MIL "ON" DTC P0401 and/or Rattle After Cold Soak

Service Category Engine/Hybrid System

Section Emission Control

Production Change Information

Figure 1.

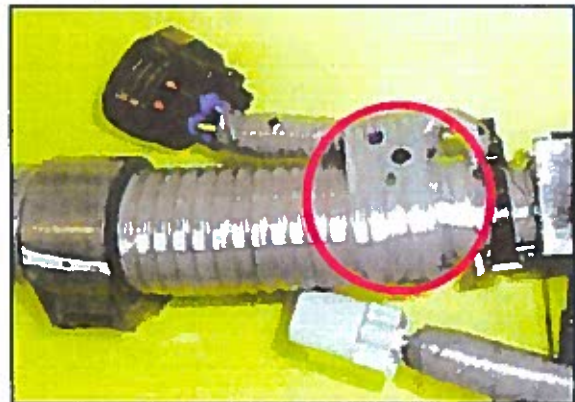
1. Modify the wire harness using the following procedure.
 - A. Remove the vinyl tape wrapped around the main harnesses and EGR harness.

Figure 3.

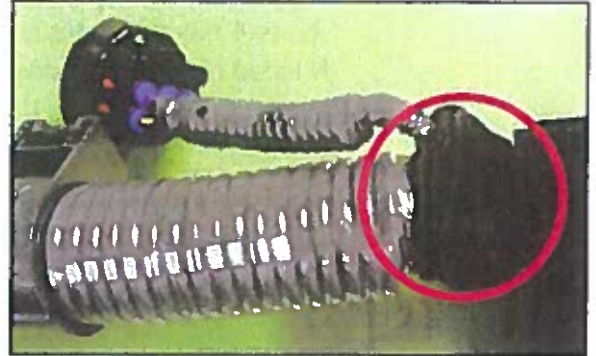
- A. Wrap the exposed zip tie 7 – 8 times with heat resistant vinyl tape.

Figure 4. Location of Authorized Modification label for 2010 - 2012 Prius and 2010, 2012 Prius PHV.

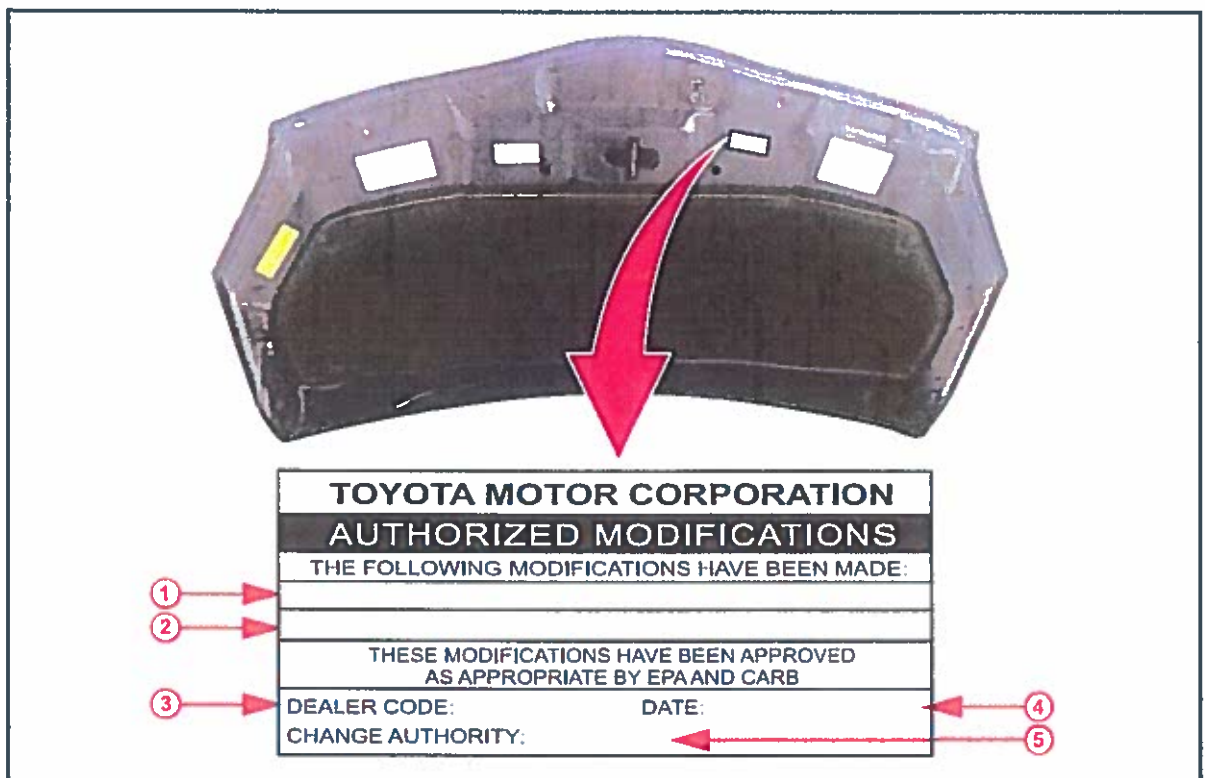
1. Check for the Authorized Modifications Label affixed to the vehicle in the location shown in Figure 4 below. Confirm if the ECM (PCM) calibration has been updated. If the calibration ID listed is NOT the latest ECM (PCM) calibration — go to step 5. If the calibration ID is the latest, go to step 7.

Figure 5. Location of Authorized Modification label for 2012 Prius V.

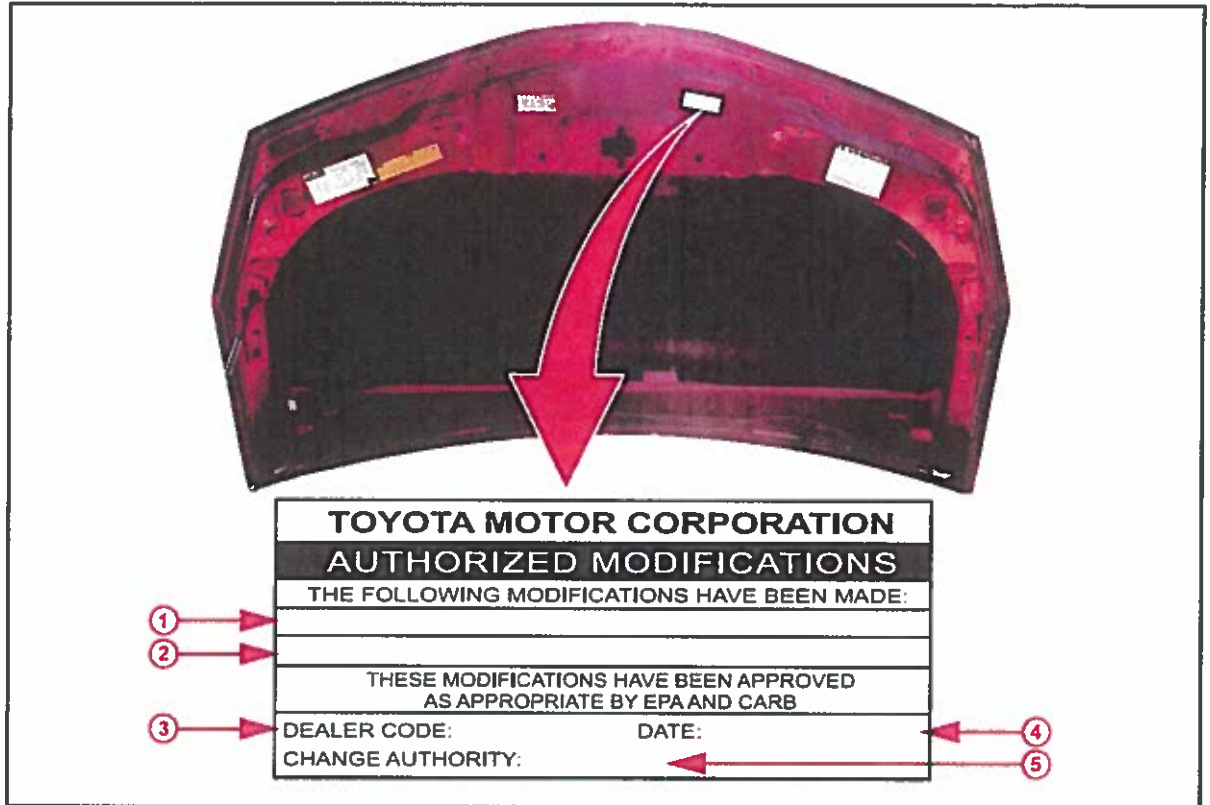
3. Install the Authorized Modifications Label.
 - A. Using a permanent marker, enter the following information on the label:
 - ECM part number *[Refer to the **Parts Information** section for the **NEW PART NUMBER**]*
 - Calibration ID(s) *[Refer to the **Calibration Information** section for the **NEW CALIBRATION**]*
 - Dealer Code
 - Repair Date
 - Change Authority **[This bulletin number]**
 - B. Affix the Authorized Modifications Label to the vehicle at the location shown in Figures 4 and 5. The Authorized Modifications Label is available through the MDC, P/N 00451-00001-LBL.
4. Confirm the repair.
